SERVICE BULLETIN # 00165

SUBJECT: Installation of Anti-Bridging Plate Assembly for specified areas and packages

MODELS: GIII

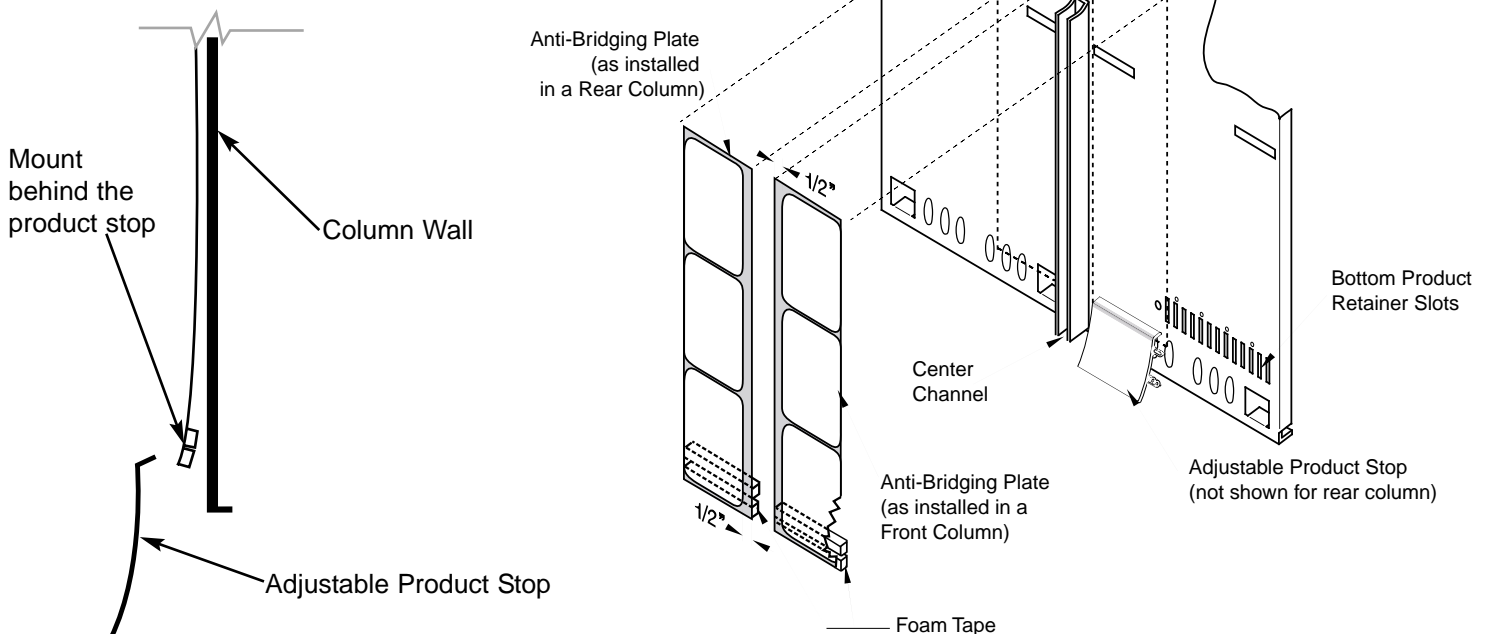
1. Unload column to be retrofitted.
2. Peel the backing from the 2 pieces of the "two-sided" tape (on the rear of the "Anti-Bridging Plate").
3. Place the "Anti-Bridging Plate" on the column wall against the center channel (divider between the front and rear columns). Make sure that the edge of the "Anti-Bridging Plate" with 1/2" of metal exposed is aligned against the center channel as shown in figure 1. Locate the bottom edge of the "Anti-Bridging Plate" just beneath the top edge of the adjustable product stop as shown in figure 2.

1. There is only one "Anti-Bridging Plate" per kit and it is to be installed on the right column wall with the foam tape at the bottom.
2. Make sure that the column wall is dry and clean before applying the anti-bridging plate.
